# **Commercial Preliminary Development Plan (PDP)**

Bank of America – 1801 NW Chipman Rd  
Application #: PL2025307  
City Council Hearing 2/24/2026

# Project Details - Site Plan

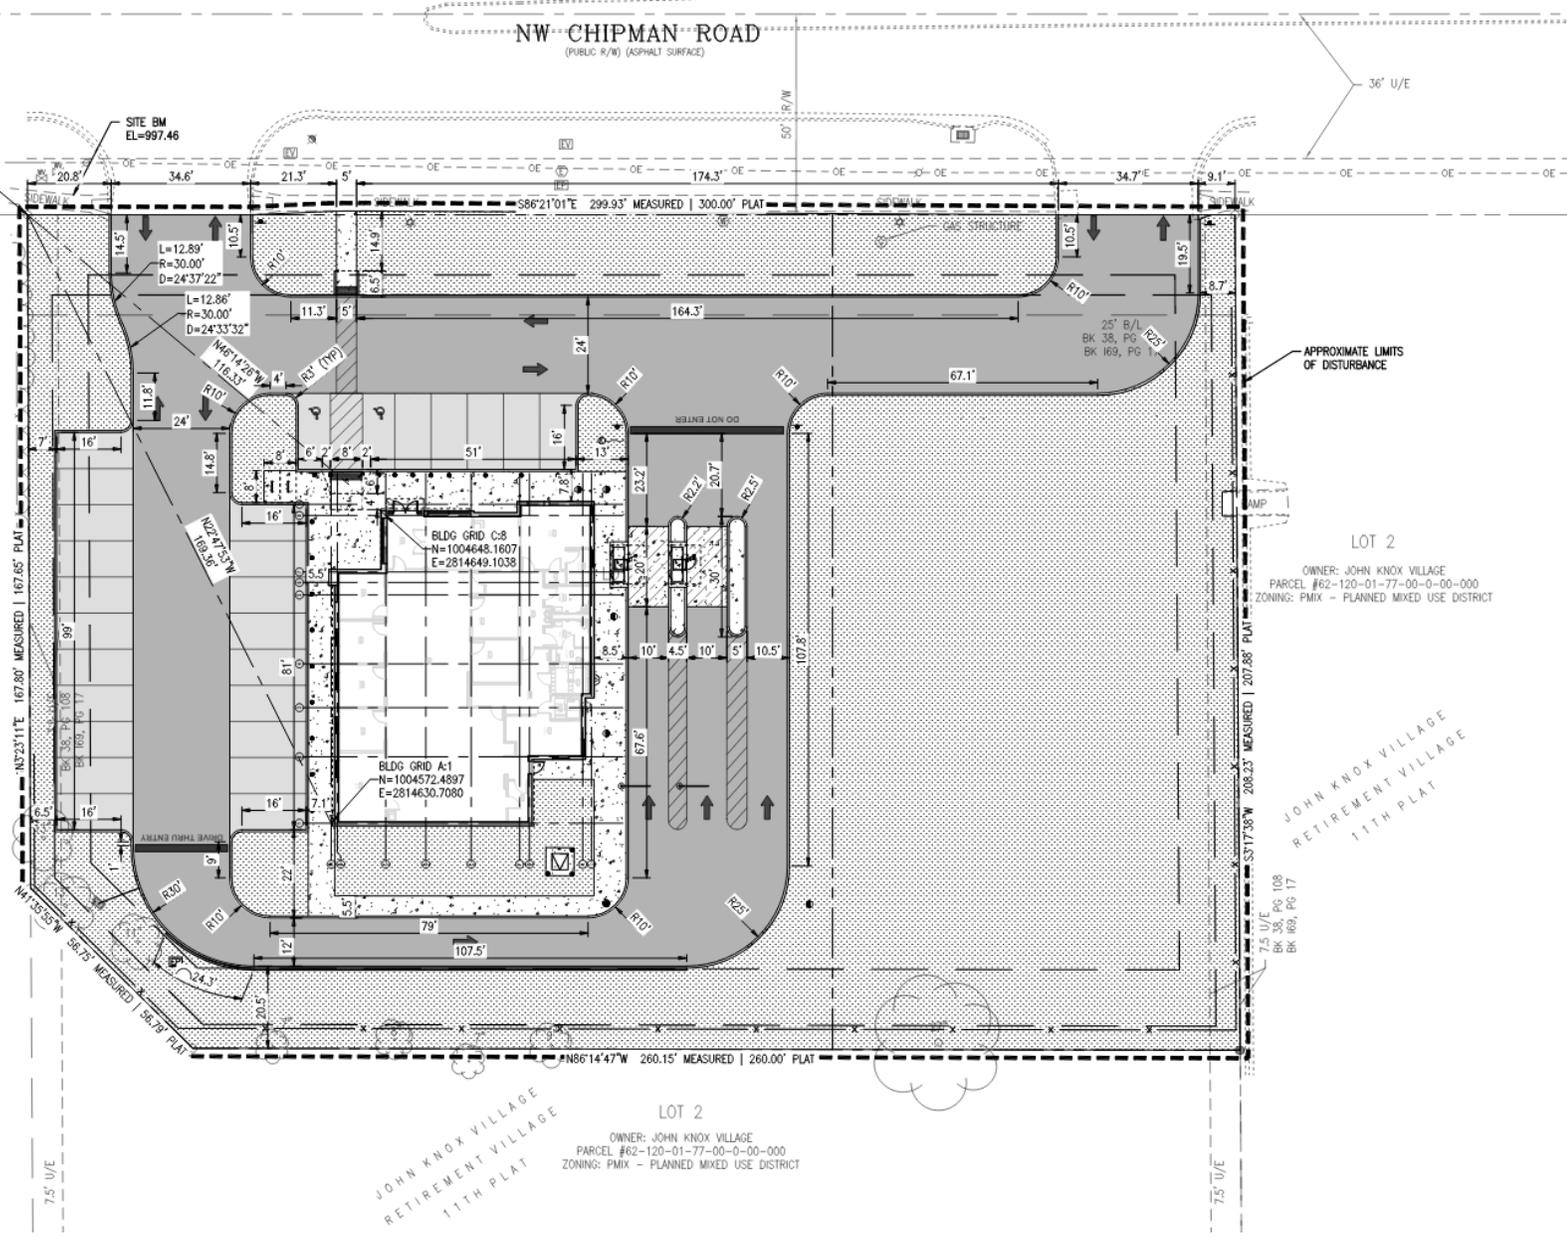
- Comment: PARKING DESIGN. A minimum 20' parking lot setback is required from any adjacent residential use. The western boundary of the proposed parking lot is set back 8'-6" from the abutting residential property. A modification to the minimum parking lot setback shall be required to be approved as part of the subject preliminary development plan process. Staff will support granting a modification to allow the parking lot setback as shown on the plans.

- Response: A modification to the parking lot setback on this side is requested (from 20' to 6' as shown in plans)
- Comment: PLATTING. Please note that the future subdivision of the subject property will require a replat of the site via the minor plat or final plat process. This process need not be undertaken until such time as the current property owner intends to convey a portion of the subject property to a separate party.
